Re: Harbourside Shopping Centre Redevelopment Modification 3 Amend the Tower Height and Podium - SSD-7874-Mod-3 (MOD 3) - Submission on Behalf of the Owners of Strata Plan 49259 (One Darling Harbour)

**SSD 7874 Redevelopment of the Harbourside Shopping Centre
Addendum to Presentation made to the Independent Planning
Commission**

SSD 7874 Redevelopment of the Harbourside Shopping Centre Submission on Visual Effects and Impacts of proposed further amended application

**ONE DARLING HARBOUR RESIDENTS – HARBOURSIDE SHOPPING CENTRE
MODIFICATION 3**

Figure 1
Principle for more appropriate view sharing
(Adapted from part of Page 3, FJMT Supplementary Architectural Design Report)

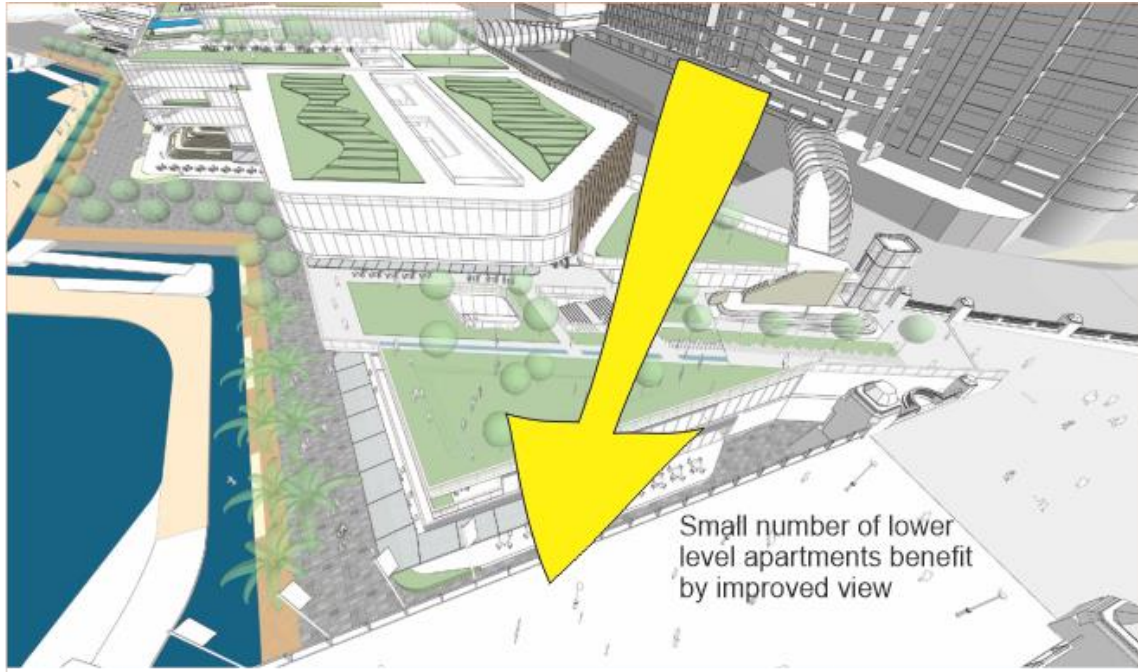
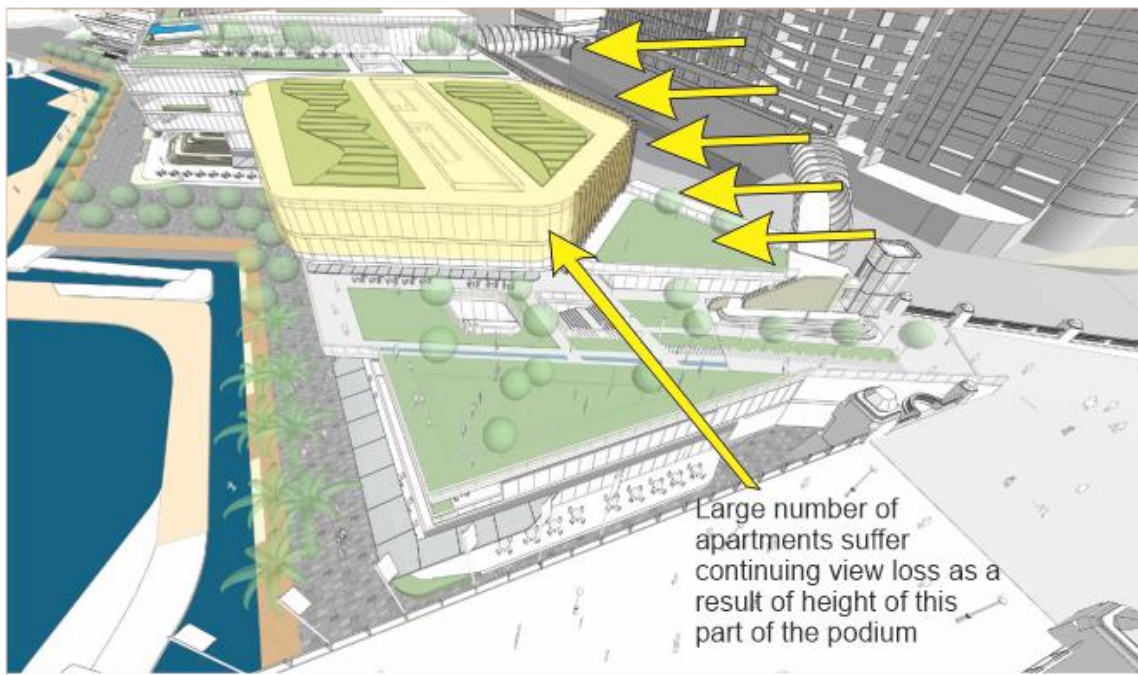
The figure below that I adapted from the Supplementary Architectural Design Report by FJMT prepared for Mirvac shows eloquently what the massive and over-height northern section of the podium does to views from 1 Darling Harbour. The upper two storeys of the area coloured yellow, in what is described in the Draft Development Consent as the Northern Podium Articulation Zone, is the culprit in causing unreasonable view loss to levels of One Darling Harbour that currently have whole, water views of Darling Harbour.

The shape of the area in plan that is proposed to be included in the potential Guardian Square plaza is of limited benefit in view sharing to One Darling Harbour. This is illustrated in the figure above and in the photomontages prepared by Virtual Ideas. However, the lower podium is an improvement to the views from a small number of units, that is appreciated.

The benefit should be extended by moving the south boundary of the lowered section of the podium further south and on an alignment more directly easterly relative to One Darling Harbour, to the alignment of the next step in height in the podium that is currently proposed further to the south.

Figure 1
Principle for more appropriate view sharing
(Adapted from part of Page 3, FJMT Supplementary Architectural Design Report)

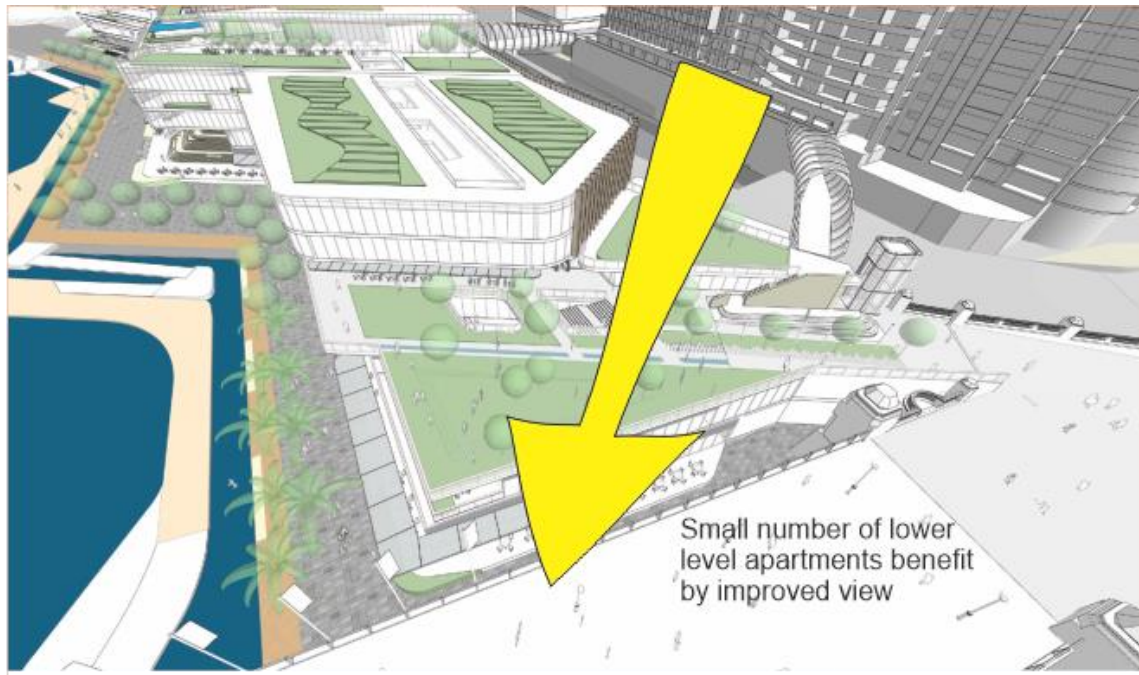
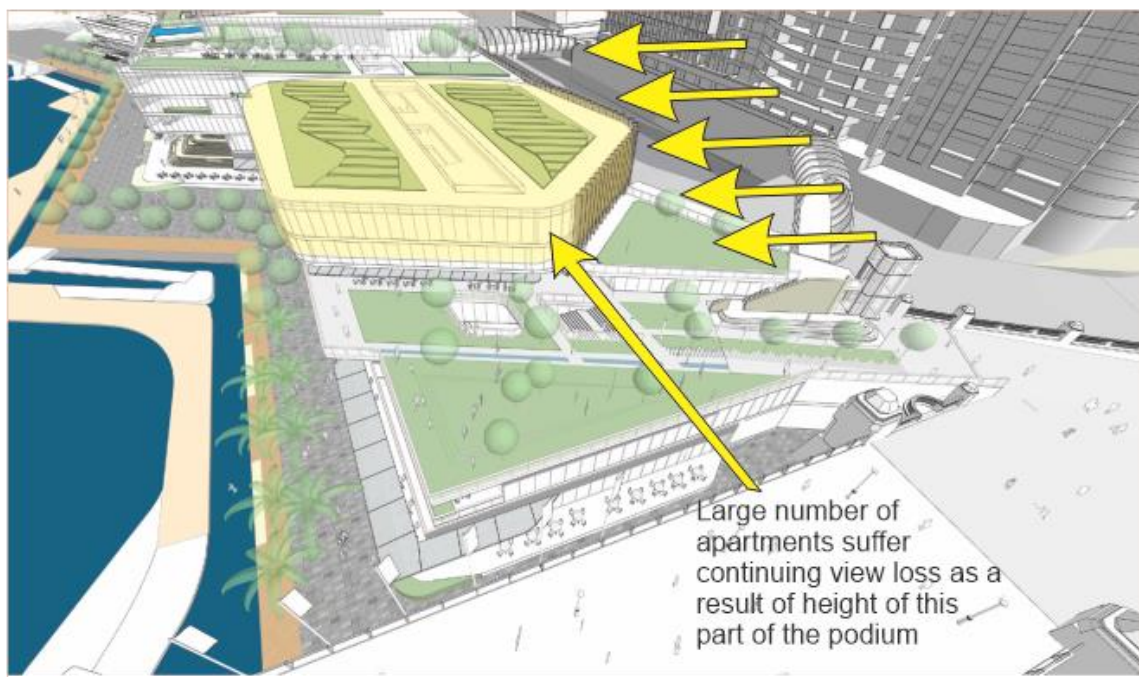
The shape of the area in plan that is proposed to be included in the potential future plaza is such that it is of limited benefit in view sharing however, as it is at its narrowest toward One Darling Harbour and the part that extends more widely to form the plaza and link to Harris Street is largely out of view, blocked for most apartments by the higher part of the north-east section of the podium. The main reasons for the shape of the 'cut out' on the podium appear not to be primarily to achieve view sharing, although there is a minor benefit there, but are the alignment with a formal link to Harris Street, space for a link across Darling Drive to One Darling Harbour and a link to the foreshore.

The lower podium is an improvement to views from One Darling Harbour that is appreciated, but the benefit should be extended by moving the south boundary of the lowered section of the podium further south and on an alignment more directly easterly, for example to the alignment of the next step in height in the podium that is proposed further to the south.

I have noted the part of the podium that is still of concern with regard to view sharing with One Darling Harbour on Figure 1 below, by means of a transparent yellow fill on a graphic adapted from Image 31 from the FJMT Supplementary Architectural Design Report. The slot in the podium benefits a small number of apartments, whereas the height of the part of the podium shaded yellow causes continuing unreasonable view loss for a much larger number. Reconsideration of the height of this part of the podium could provide a satisfactory outcome for One Darling Harbour in terms of view sharing.
